Proposal for amendments to Regulation No. 55 (Mechanical couplings)

The text reproduced below was prepared by the expert from Germany to clarify the present text of Regulation No. 55. It is a revision of document ECE/TRANS/WP.29/GRRF/2011/7. The modifications to the existing text of the Regulation are marked in bold for new and strikethrough for deleted characters.

"11. Dedicated drawbar type couplings —**with or without jaw, with or without coupling pin** — Class T

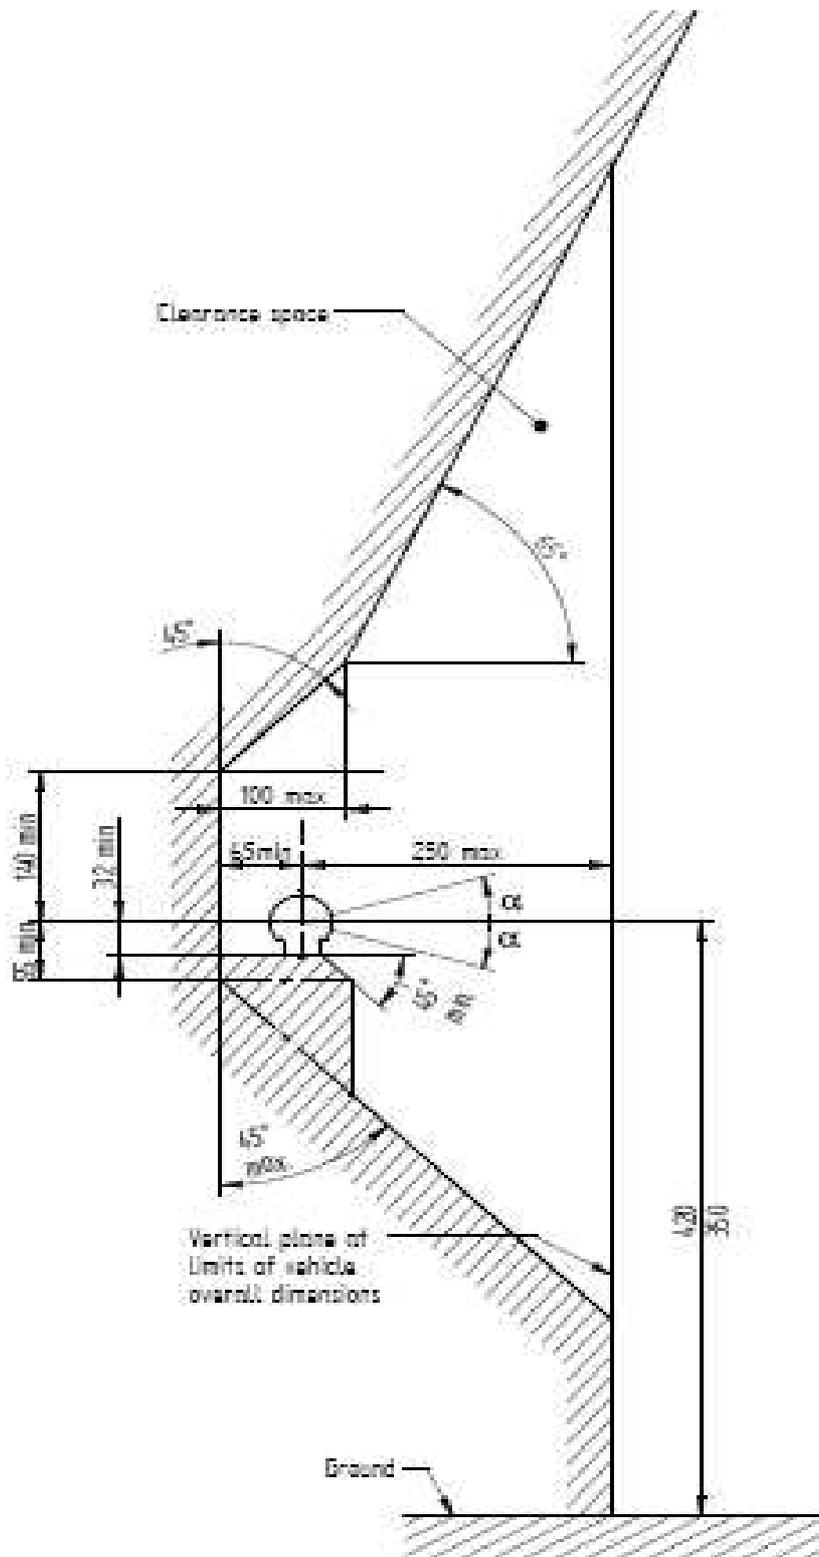
Annex 5, paragraphs 11. and 11.1., amend to read:

11.1. Class T dedicated drawbar type couplings —**with or without jaw, with or without coupling pin**— are intended for use on specific vehicle combinations, for example, car transporters. These vehicles have special structures and may need particular and unusual location of the coupling."

Annex 7, figure 25(a), amend to read:

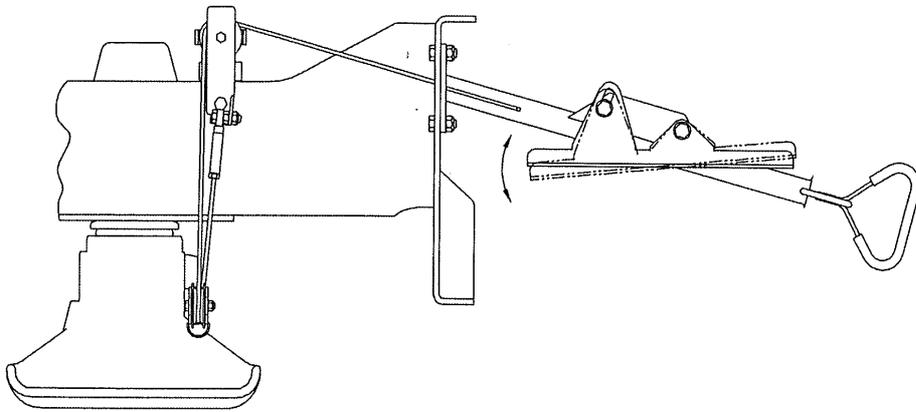
4. In the figure, the end of the line limiting the clearance zone above the ball ends together with the vertical line used to show the horizontal distance. The purpose of the requirement is to take respect also to any supplement contour or device as lifts, forks, combustors and this on. Also these parts can cause injuries while handling the coupling.

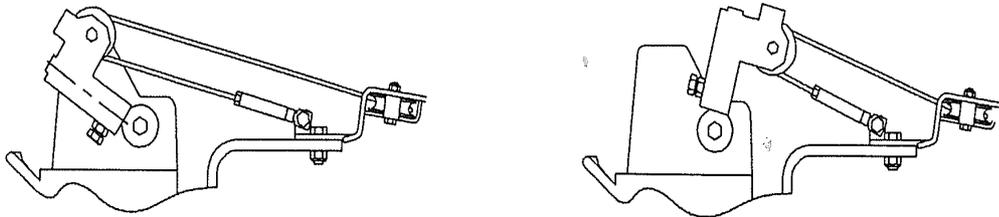
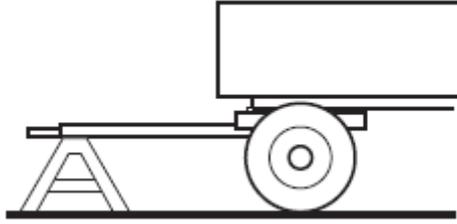
2. A remote indication is used in any case when the closed and safe coupling cannot be controlled directly in a visual way. Actually the regulation requires in point 2.9, that a remote indication must be in the cabin, meanwhile in annex 6, item 12, this restriction is not given. In case of OE manufacturing this remote control can be included within further control instruments. In case of after- market devices this solution is difficult. A remote indication is often used in case of low coupling combinations. Here it is good to have the remote indication near at the rear of the vehicle. So the driver can control the coupling and connect electrical and pneumatic connectors. The possibilities, where to place the remote indication should be free to the manufacturer. See drawing below as example for sidewise controlled coupling
